SIEMENS

January 27, 1997
JBE:97:014

License No. SNM-1227
Docket No. 70-1257

- Ref.: 1. Letter, K. J. Hardin to L. J. Maas, "Request for Additional Information, Low Level Radioactive Waste Shredding and Uranium Recovery", (TAC NO. L30896), dated December 10, 1996.
2. Letter, K. J. Hardin to L. J. Maas, "Request for Additional Information, Low Level Radioactive Waste Shredding and Uranium Recovery", (TAC NO. L30896), dated December 23, 1996.

ATTACHMENT 6 - Steam Boiler (UT-SG-501)

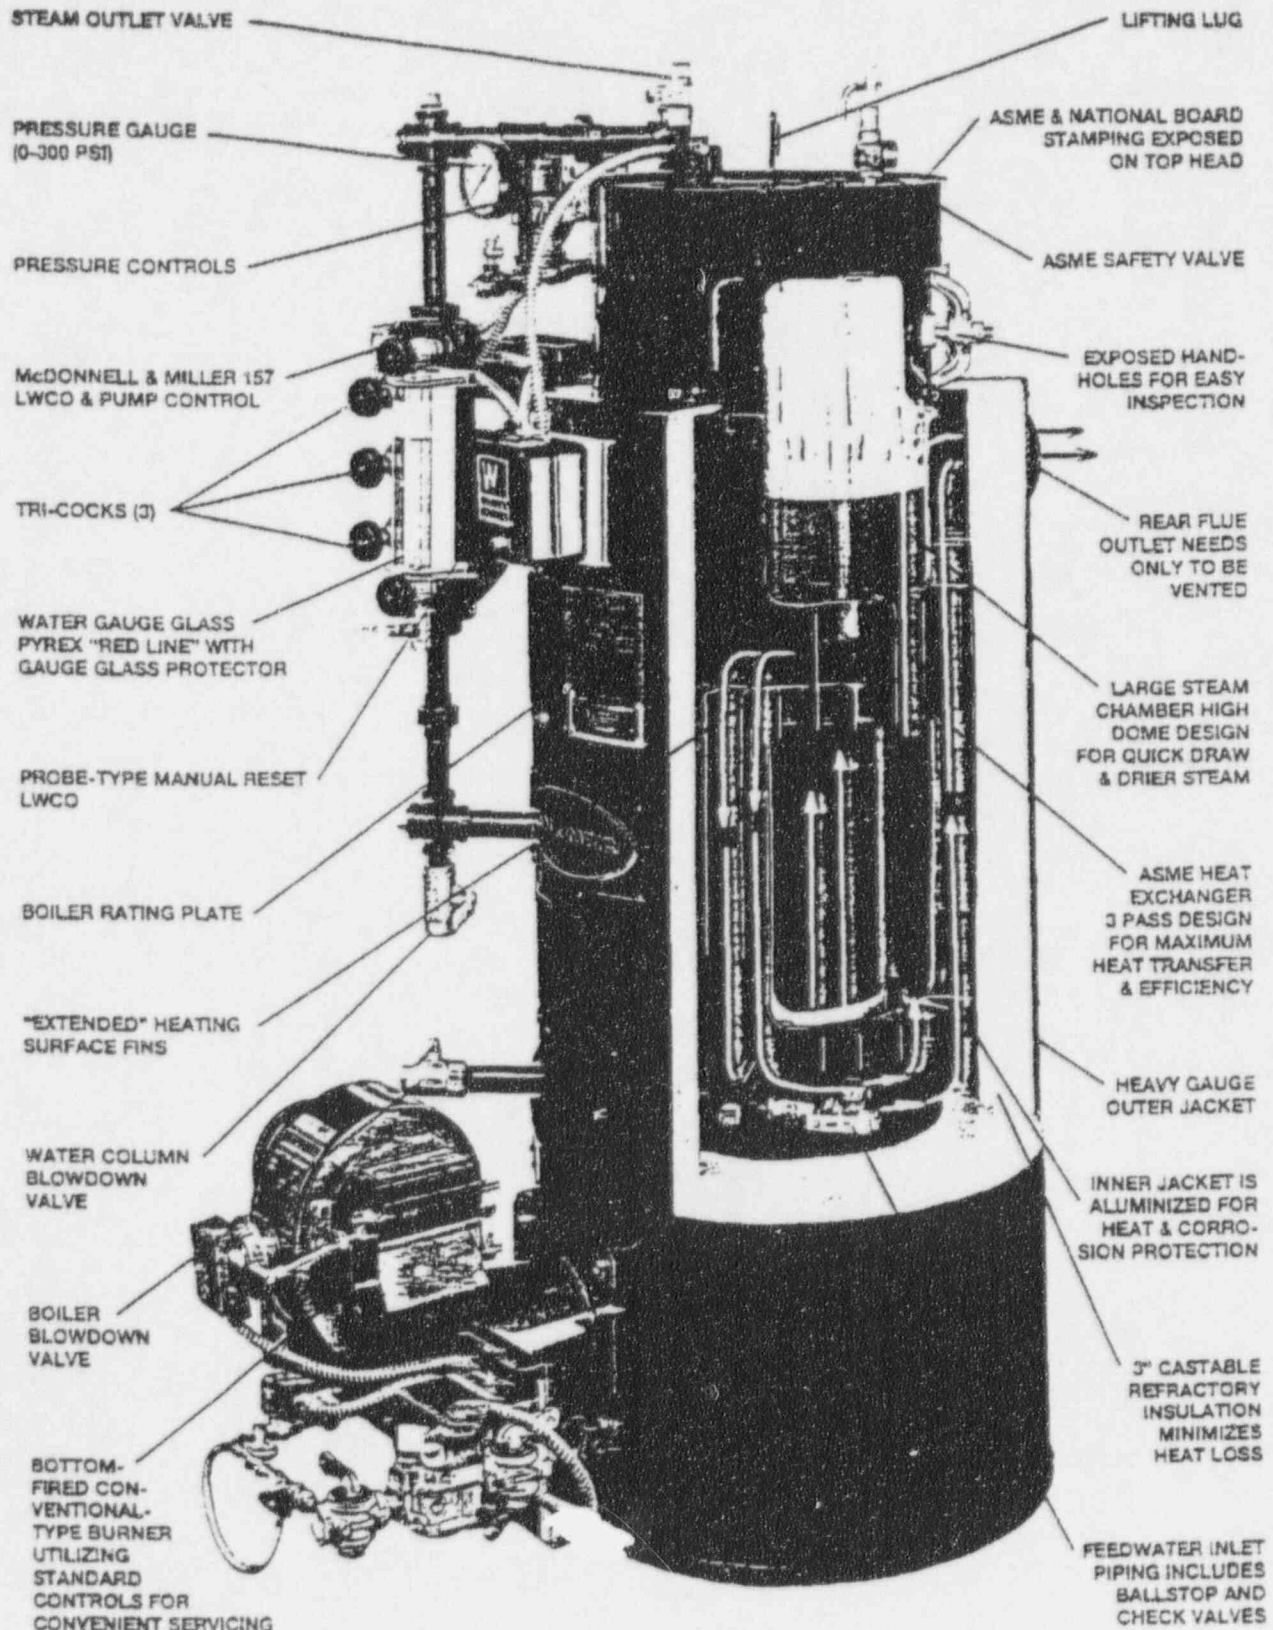
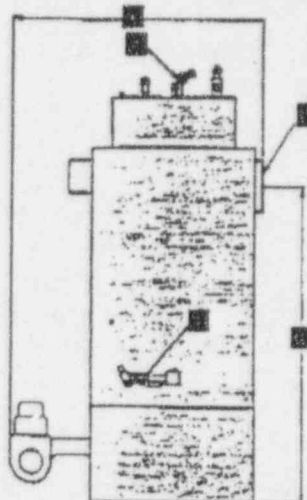
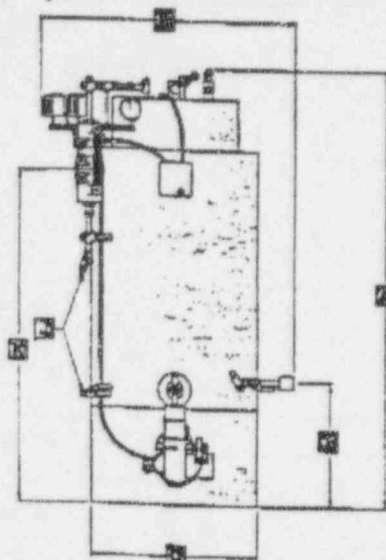
- 2.3 How are the chemicals storage room and the steam generator area separated from each other? Describe the construction of the separating wall, if any. Describe the steam generator, including its capacity and the method of heating.

There is no barrier wall in the Raw Material/Storage Area to separate the steam boiler from the chemical storage totes and drums. This was not considered necessary for basically two reasons. First, propane is not stored in bulk in the Raw Material/Storage Area but is piped from another facility approximately 150' away from the MERF. Thus, a boiler explosion or fire would not ignite a large volume of propane potentially endangering the integrity of the chemical storage containers. Second, the boiler is designed with an outer steel jacket that covers three (3) inches of castable refractory insulation. This material provides not only thermal insulation, but also reduces the potential for projectiles to result from a boiler failure. In essence, the boiler jacket acts as a separating wall from the remainder of the Raw Material/Storage Area. Detailed vendor information regarding

the boiler can be found in Attachment 6. The boiler generates 500,000 BTU/hr (15 BHP or 517 lbs/hr steam @ 150 psig) using propane gas.
